From: Ryan M. Mones [mailto:RMMones@sgh.com]
Sent: Tuesday, June 06, 2017 10:04 AM
To: Carley, Edward; Greene, Joshua
Cc: Brown, Brian
Subject: site visit topics, part 1

Talking Points for Audit Questions

June 2017

Dynamic Soil Pressures

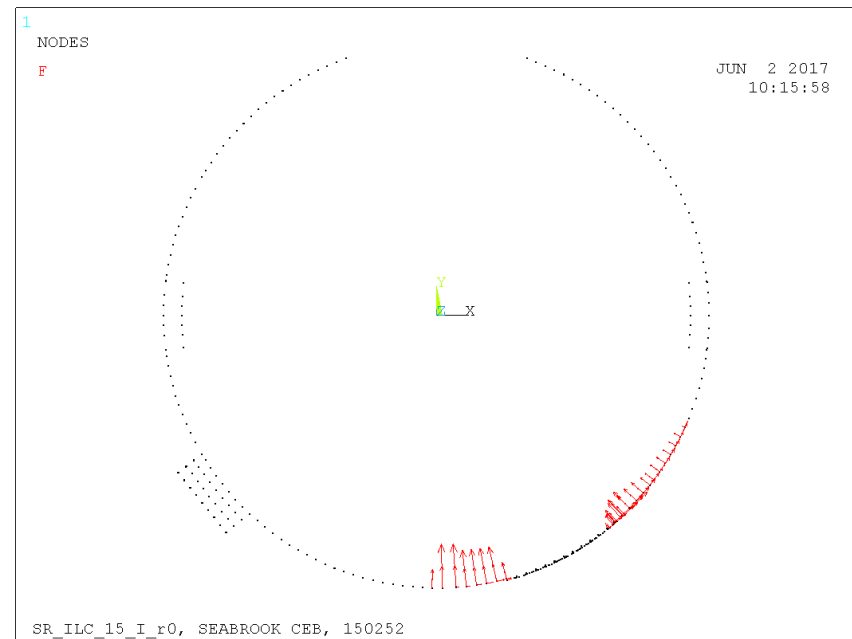
NRC noted that “The magnitudes in the two opposite seismic directions are significantly different in some cases”...

- Dynamic soil pressures are not symmetrical for north/south direction of loading due to presence of soil and penetrations.
- Responses are local and direction-dependent. Reversing the direction of load does not necessarily invert the response.

ASR Load Factors, Question 3

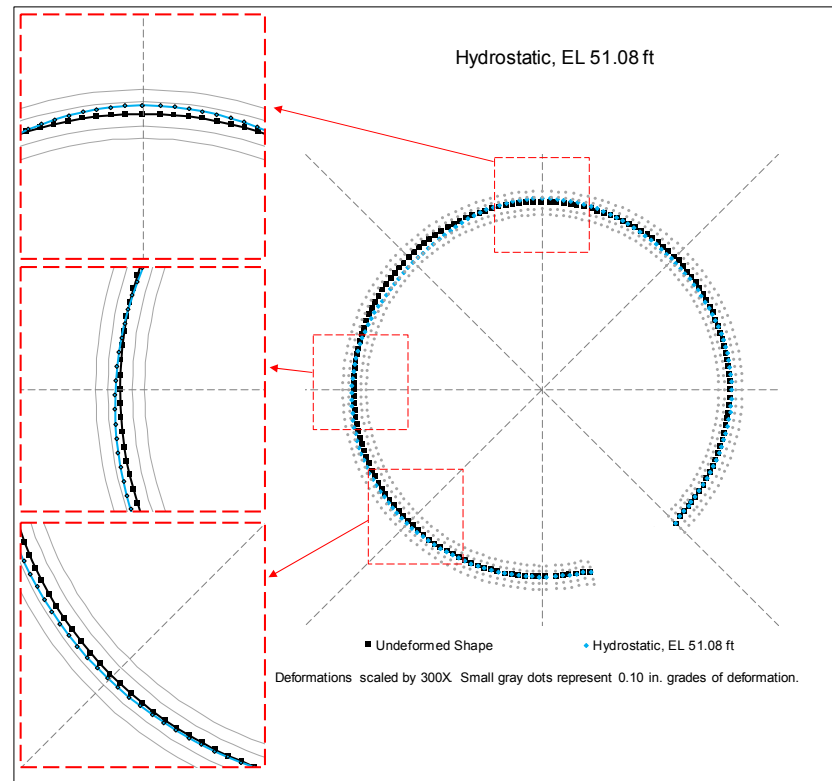
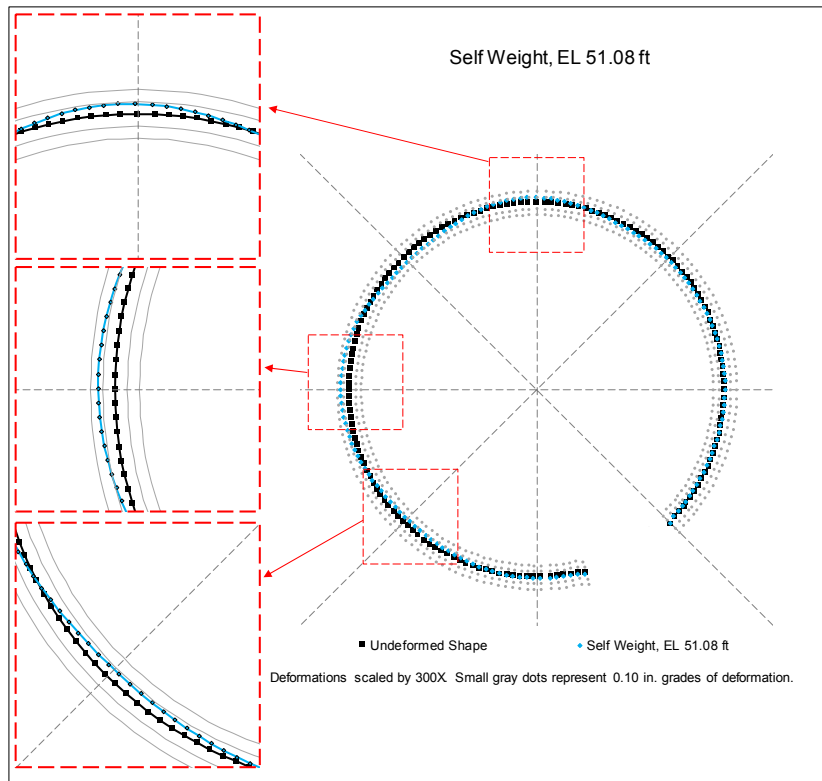
The NRC hand calculation suggests lower ASR deformation than indicated by CEB calculation.

What is the difference between the displacement calculated in the ANSYS ASR-only analysis and the displacement calculated in the ANSYS unfactored static load combination analysis?

- The large penetrations in the CEB causes ASR deformations to be larger than the suggested hand computation. While the effects of the penetrations reduce as you move higher up on the CEB, they do not go away completely.

- Plots of deformed shape provide a more comprehensive understanding on the CEB behavior.
- Deformation contributions of individual load cases are tabulated for select locations.
